Software limitations related to STEVAL-BCNKT01V1 lot 1720

This errata sheet applies to the STEVAL-BCNKT01V1 lot 1720 when using FP-AUD-SMARTMIC1 (v1.2.0 or above).

Figure 1. Board identification (1720)

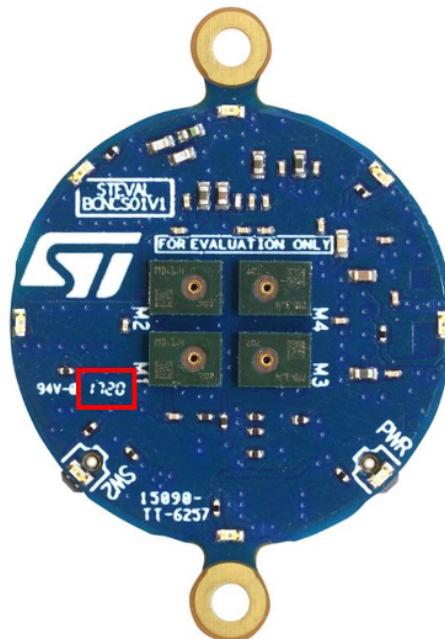
The STEVAL-BCNKT01V1 (BlueCoin) production lot "1720" mounts MP34DT04-C1 MEMS microphone instead of MP34DT06J.
